**REMEDIAL DESIGN WORK PLAN AND DESIGN REPORT
FOR SEAD-4 AND SEAD-38
SENECA ARMY DEPOT ACTIVITY**

**FINAL
REMEDIAL DESIGN WORK PLAN AND DESIGN REPORT
FOR THE MUNITIONS WASHOUT FACILITY (SEAD-4)
AND THE BUILDING 2079 BOILER BLOWDOWN PIT (SEAD-38)
SENECA ARMY DEPOT ACTIVITY**

Appendix C: Response to Comments

Drawing C-3 SEAD-4 and SEAD-38 Excavation Plan

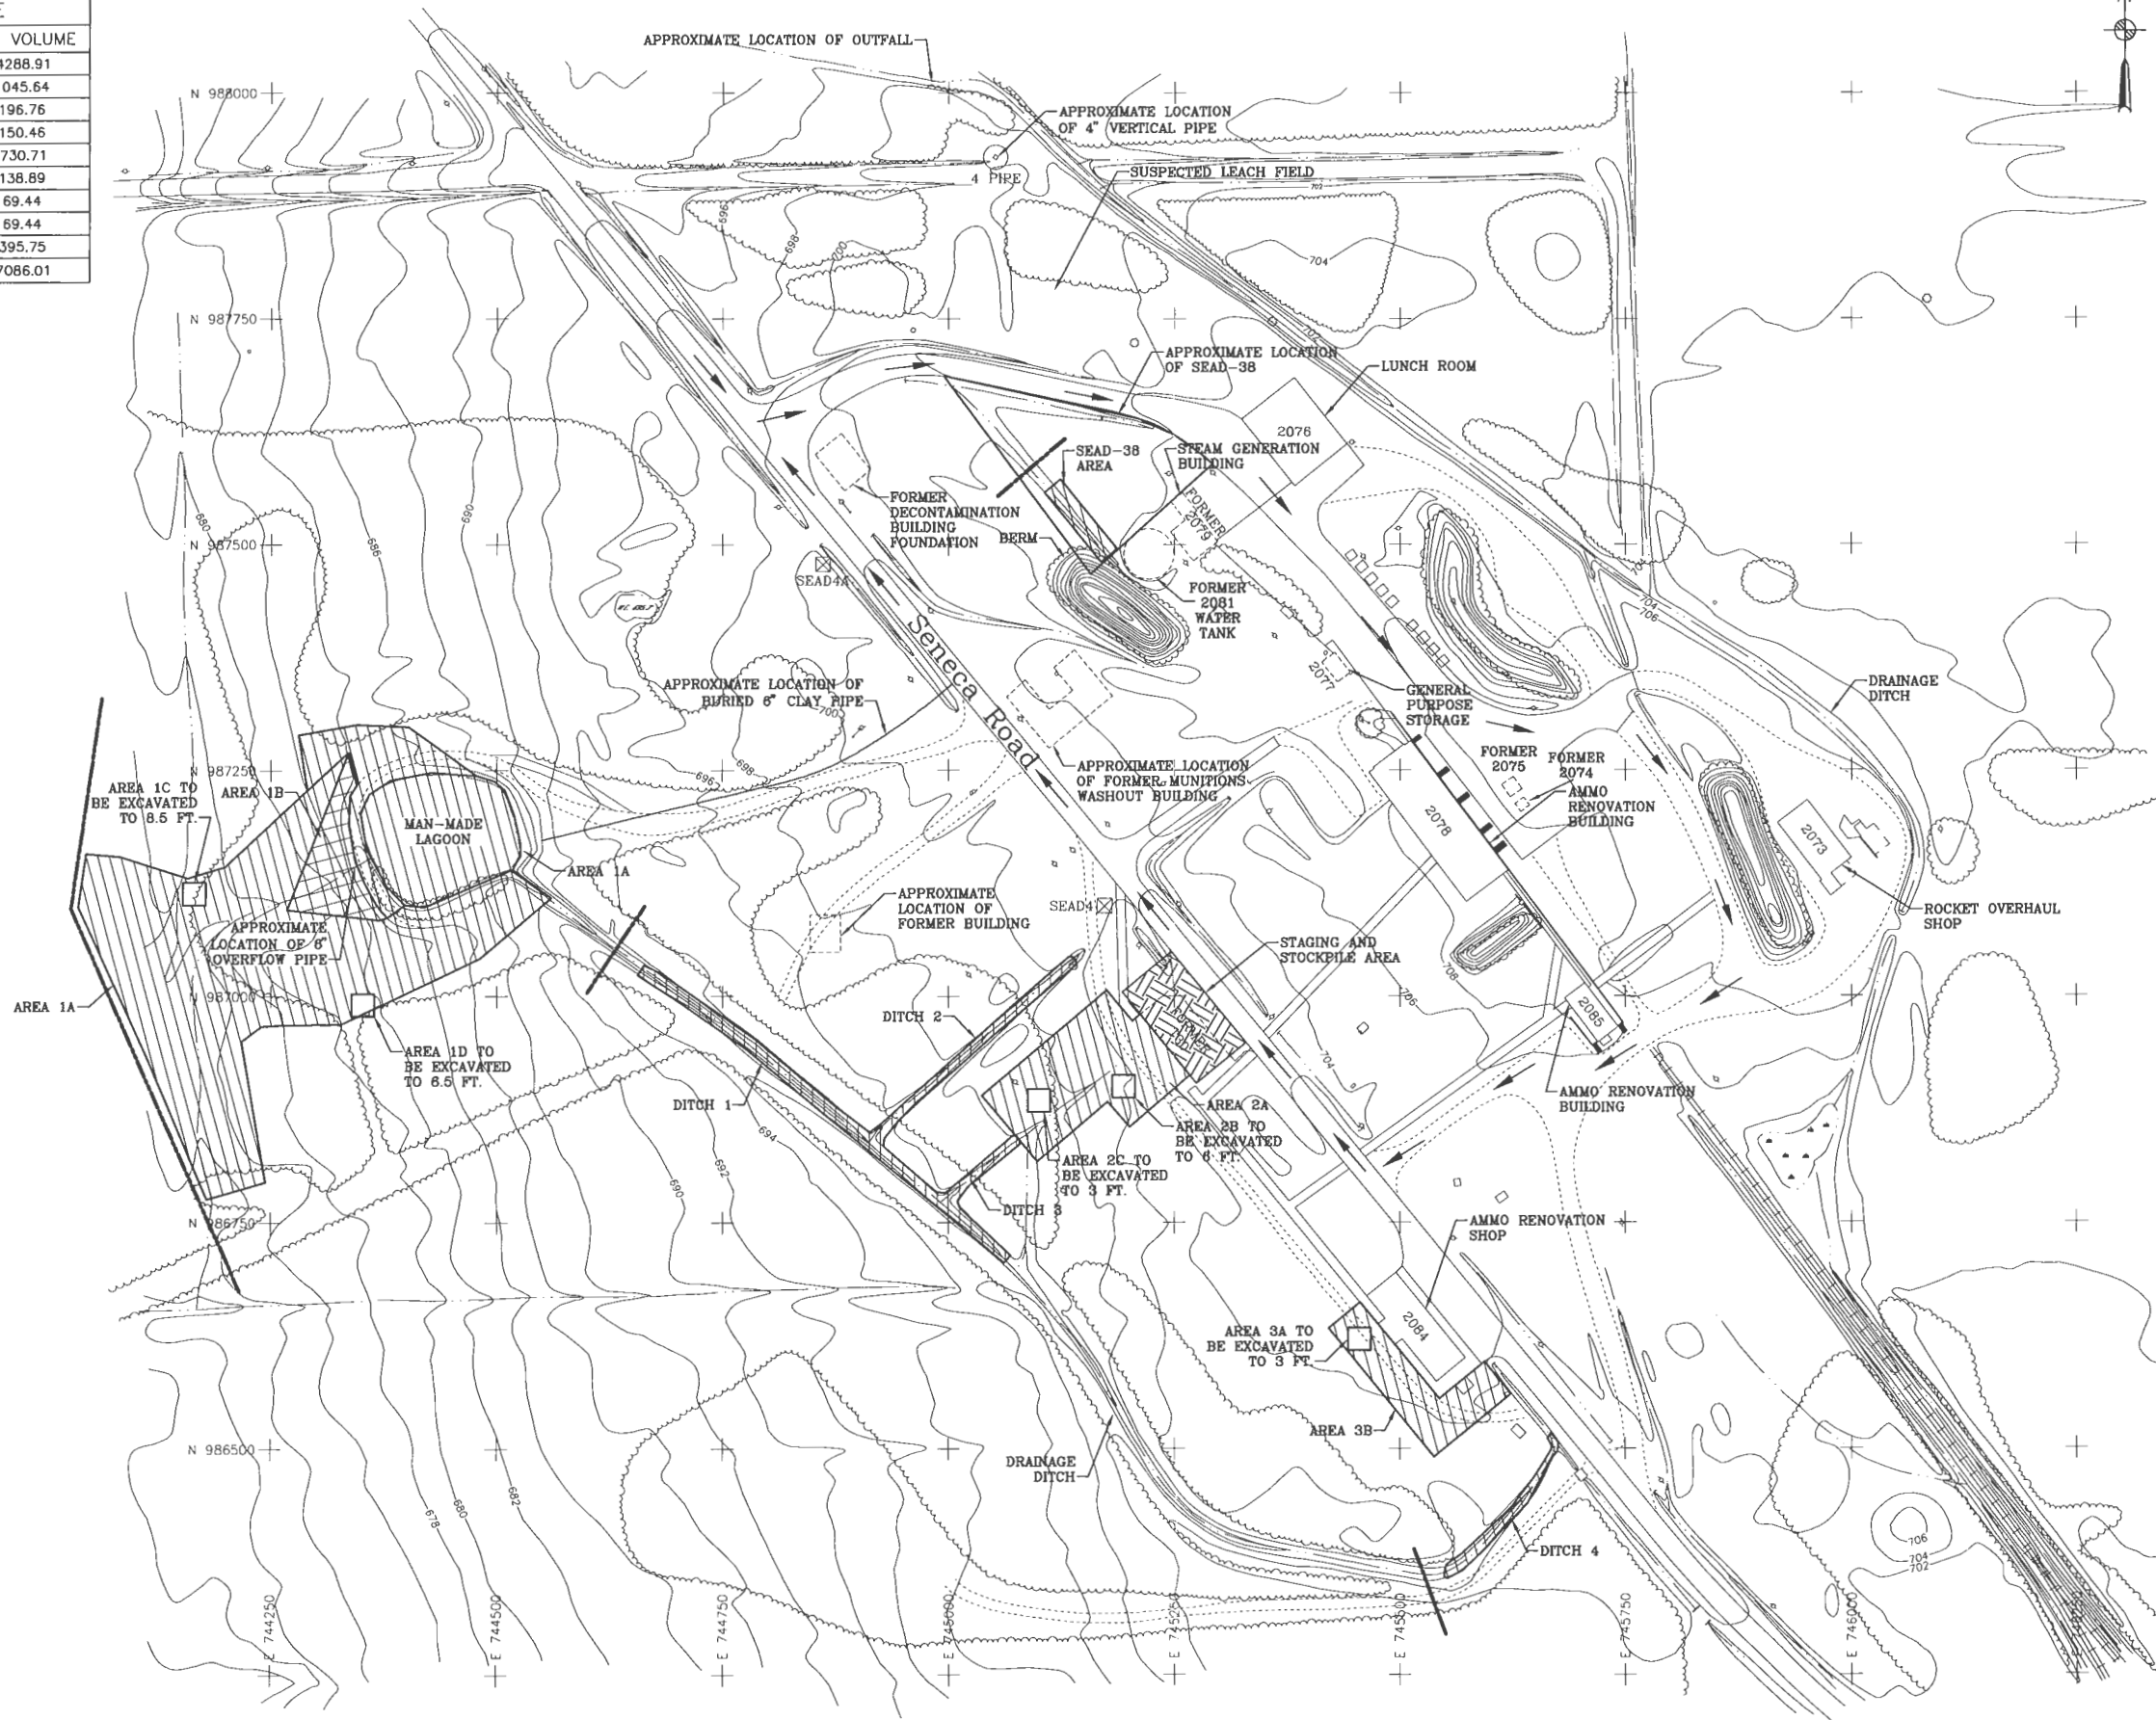
Comment 2: Sections 3.3.2 and 3.3.3 discuss the use of a hauling route and stockpile/staging area shown on Figure C-3. Two hauling routes and stockpile/staging areas are shown on Figure C-3. Revise the Report to either discuss both areas on the Report or remove one from Figure C-3.

Drawing C-3 of the Excavation Plan has been revised to show the anticipated sidewall sample locations. The drawing shows that the depths of excavation in certain areas have been modified. The current excavation plan focuses the deeper excavations on the historic boring locations corresponding to chromium or lead concentrations exceeding the cleanup goals at depth. Specifically, Area 1B was reduced and two 25-feet by 25-feet boxes are included instead; Area 2A was reduced in size and replaced with two 25-feet by 25-feet boxes; and Area 3 was reduced and replaced by one 25-feet by 25-feet box.

Response 2: Drawing C-3 has been revised. The only staging area will be located in the location of former Building T-30.
